Agenda
City of Springboro Planning Commission Meeting
Wednesday, May 8, 2024, 6:00 p.m.
Council Chambers, City Building, 320 West Central Avenue

Background Information & Staff Recommendations
City of Springboro Planning Commission Meeting
Wednesday, May 8, 2024, 6:00 p.m.
Council Chambers, City Building, 320 West Central Avenue

Site Plan Review, 245 South Pioneer Drive, Buckeye Fabricating, building addition

Final Development Plan, 1525 South Main Street (SR 741), Northampton PUD-R, Planned Unit Development-Residential, residential subdivision

Front Elevation 1/8"=1'-0"

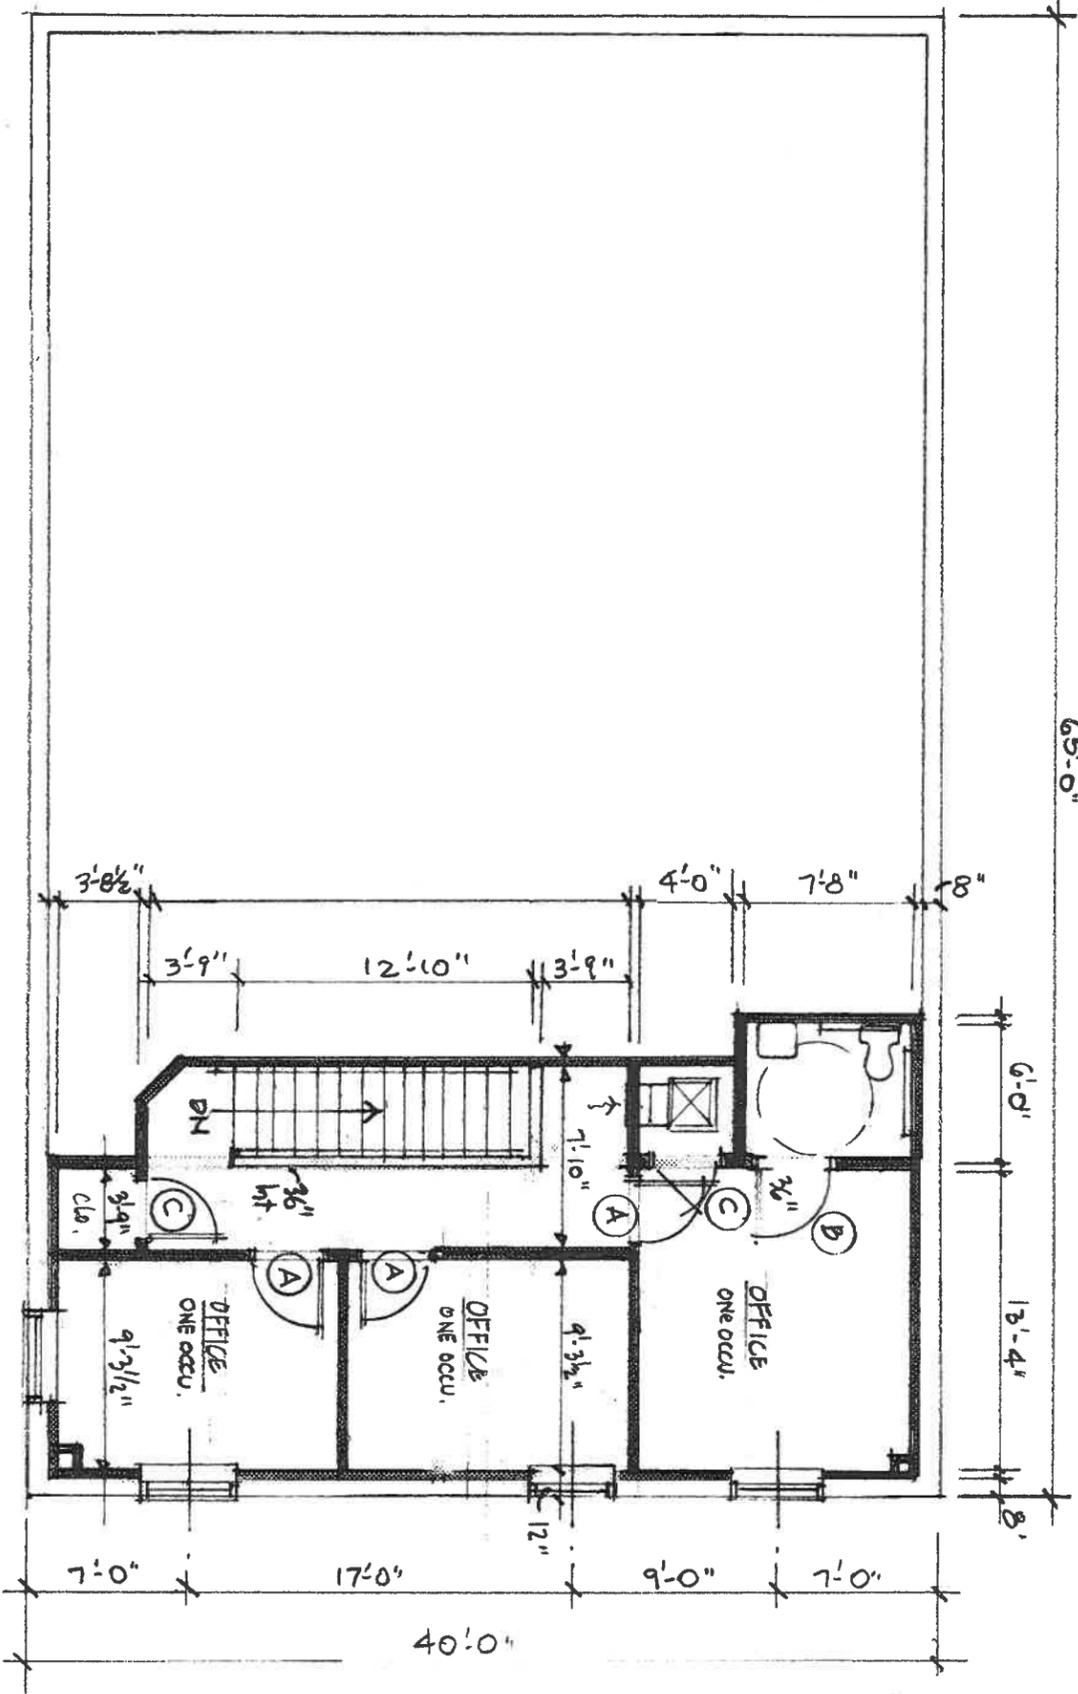
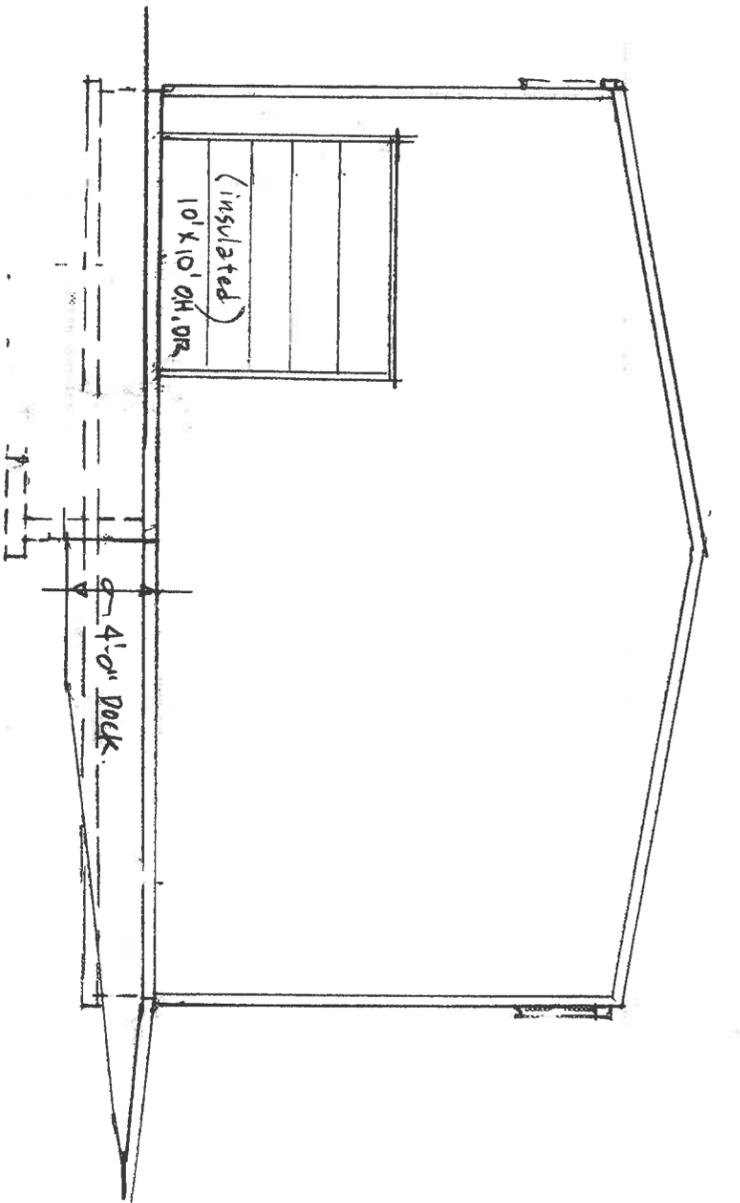
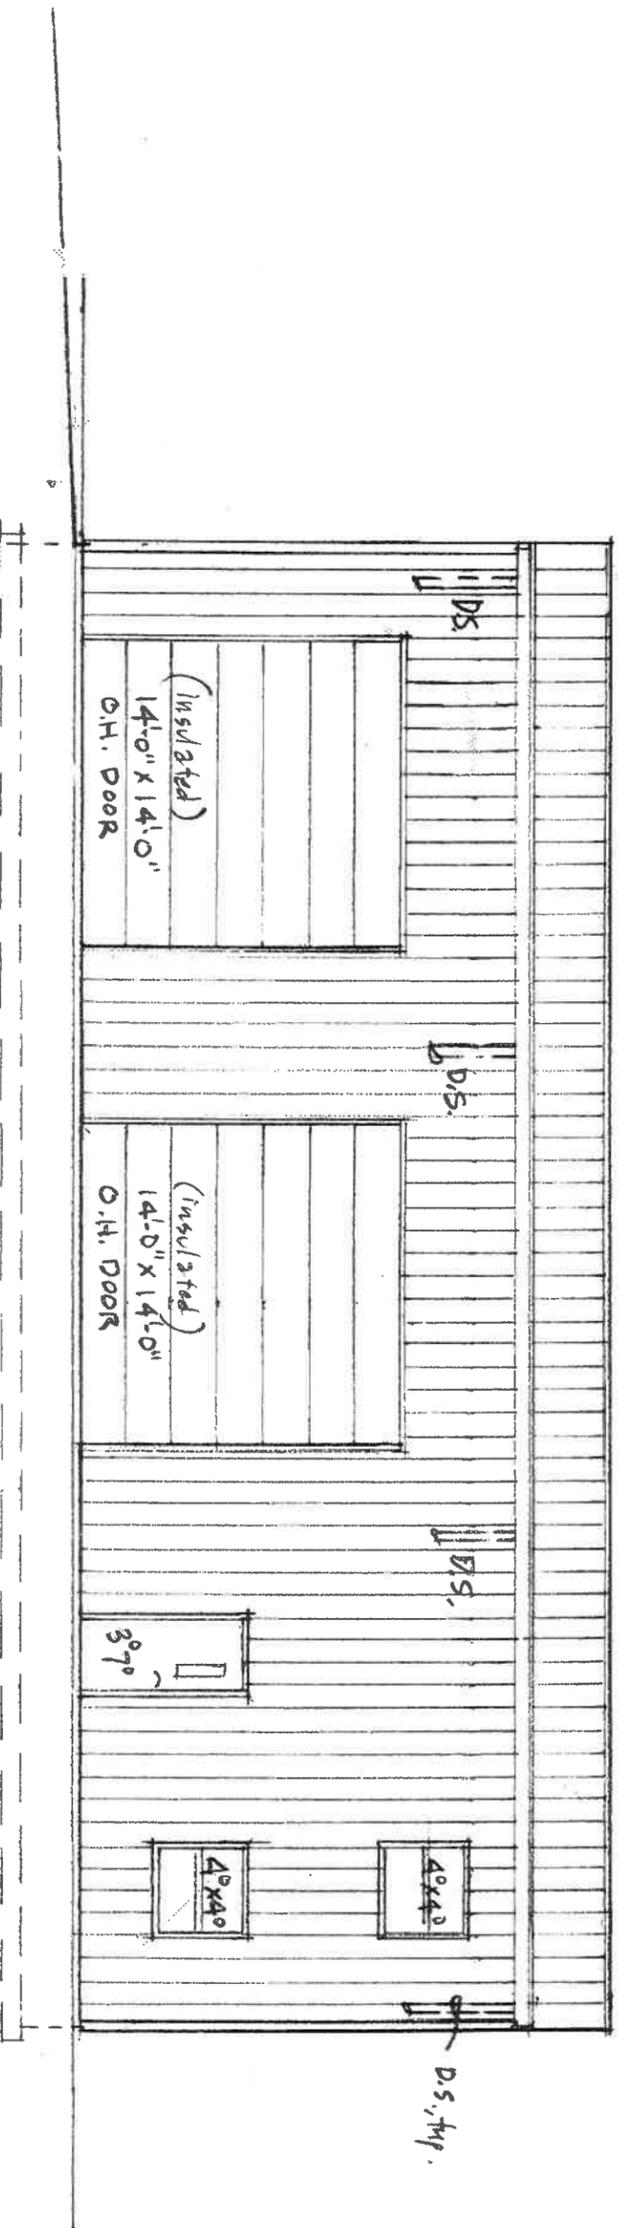
2. Setbacks established at time of site plan review process for the ED; staff recommends increasing setbacks to 35 feet.
3. For proposed building, provide architectural elevations with a graphic scale and an indication of exterior building materials.

4. Building color to be neutral color or earth tone, with one accent color. Revise rendition accordingly.
5. For the building architectural, modify plans accordingly:

- a. Provide a tripartite design with a top (e.g., cornice), middle, and base or foundation. See buildings along Commercial Way that accommodate this requirement.

- b. Use at least three exterior building materials on the elevations, and no more than four.
6. Plan to comply with provisions of Section 1264.26, Development Standards for Specific Uses, Minor and Major Vehicle Repair including the following:
